Report to: Development Services Committee

MEMORANDUM

SUBJECT: Proposed Barter Street Extension,
6845 to 6889 14th Avenue,
Boxgrove Secondary Plan Area

Figure 2 – 6845 to 6899 14th Avenue Concept Plan

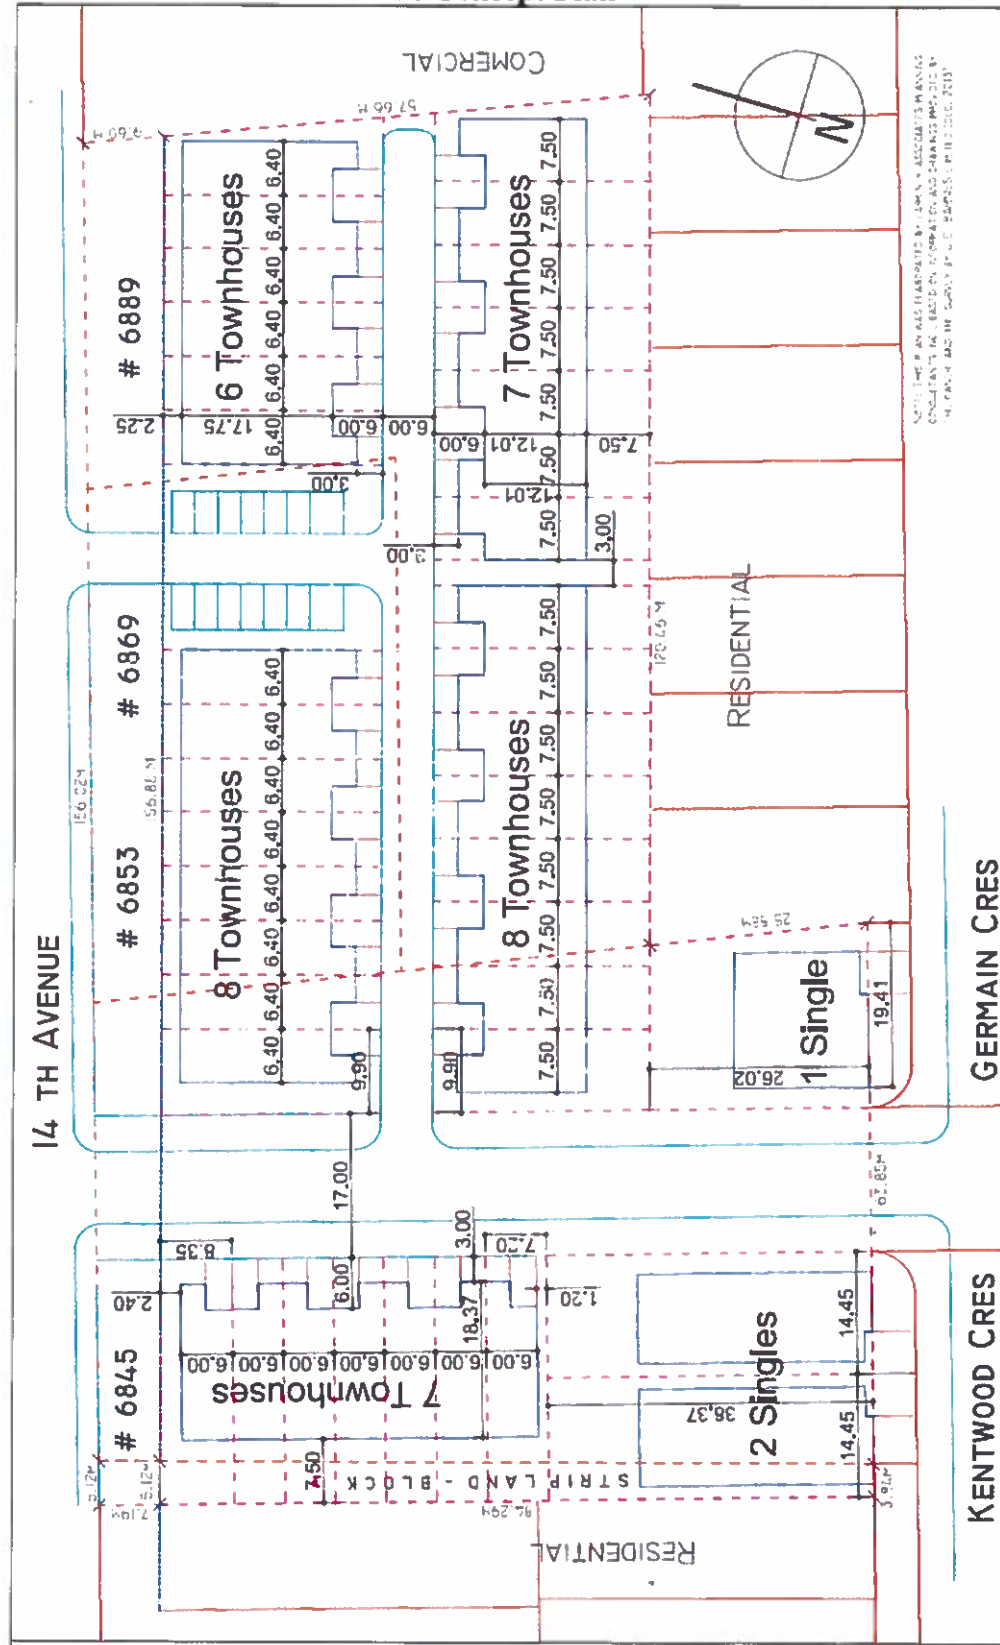
Overall, Transportation Engineering supports the new road extension. Traffic impact studies will be required as part of future development of the Bellport site, to assess traffic control options for the Barter Street / 14th Avenue intersection. Considerations must be given to the overall traffic operations on 14th Avenue in consultation with York Region.

The Fire Department is not supportive of the existing subdivision configuration which has one access point into the subdivision Barter St. and Coakwell Drive. This department requires a minimum of two independent accesses to ensure reliability at all times for responding Fire Dept. vehicles and other emergency services vehicles. A secondary water supply connection will also be required at the intersection of 14th Ave. and Barter Street to secure and enhance the pressure and quantity of the water supply.

The Fire Dept. will require Barter Street be extended to 14th Ave. to provide the necessary secondary access and water supply security.
